Item Name: Crosstube Assembly, Mid Fwd

DART AEROSPACE LTD HAWKESBURY, ONTARIO, CANADA	
DRAWING NO. D206-667-147	REV. A SHEET 1 OF 4
TITLE CROSSTUBE ASSY (206L MID FWD)	SCALE NTS
COPYRIGHT © 2010 BY DART AEROSPACE LTD THIS DOCUMENT IS PRIVATE AND CONFIDENTIAL. IT IS SUPPLIED ON THE EXPRESS CONDITION THAT IT IS NOT TO BE USED FOR ANY PURPOSE OR COPIED OR COMMUNICATED TO ANY OTHER PERSON WITHOUT WRITTEN PERMISSION FROM DART AEROSPACE LTD.

DRAWING NO. D206-667-147	TITLE CROSSTUBE ASS'Y (206L MID FWD)	REV. A	DART AEROSPACE LTD ENGINEERING ORDER		D.E.O. NO. D206-667-147-A-1	SHEET NO. SHEET 1 OF 1	SCALE NTS
DRAWN <i>q</i>	CHECKED <i>ADS</i>	MFG. APPR. <i>PS</i>	APPROVED <i>MD</i>	DE APPR. <i>MD</i>			
DATE 11.07.15	DATE 11.07.20	DATE 11.07.21	DATE 11/07/21	DATE 11.07.21

REPLACE MAGNOBOND WITH PROSEAL.

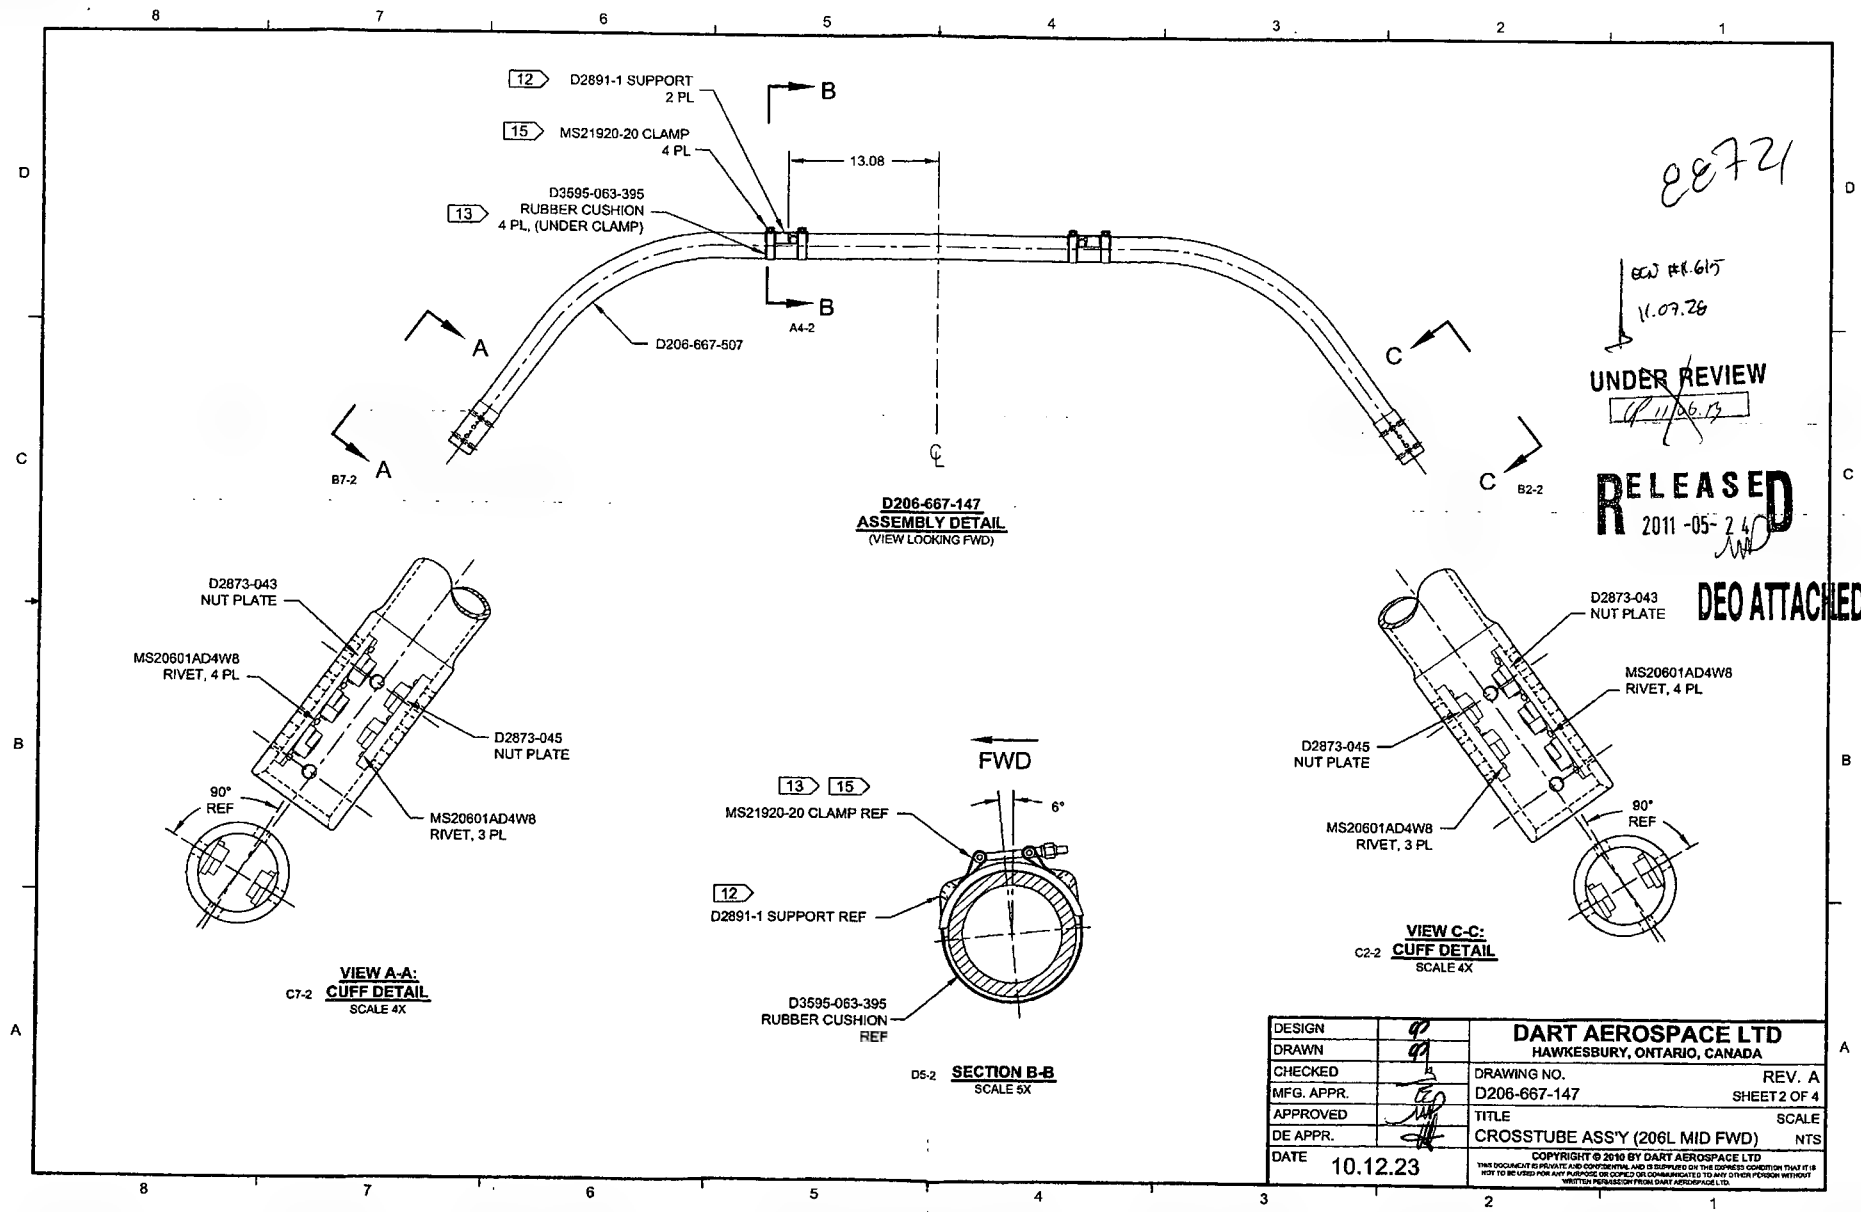
NOTE 12 & 15, SHEET 1 IS AMENDED AS FOLLOWS:

Item	Qty -147	Part Number	Description
9	A/R	PROSEAL 890 B-2	SEALANT, AMS-S-8802 CLASS B-2

- 12) TO INSTALL D2891-1 SUPPORT: ABRASE MATING SURFACE OF SUPPORT AND CROSSTUBE WITH 180-GRIT SANDPAPER AND REMOVE RESIDUE WITH MEK (OR EQUIVALENT). APPLY A 0.04" TO 0.07" THICK LAYER OF PROSEAL 890 CLASS B-2 (OR AMS-S-8802 CLASS B-2) SEALANT TO MATING SURFACE OF SUPPORT.
- 15) TORQUE CLAMPS 80 TO 100 IN-LB. ENSURE AT LEAST 1.5 THREADS SHOWING IN SAFETY AND THAT NUT HAS NOT BOTTOMED-OUT AFTER TORQUING. **PRIOR TO PACKAGING, RE-CHECK TORQUE ON CLAMPS AFTER PROSEAL 890 SEALANT HAS CURED FOR 72 HOURS.**
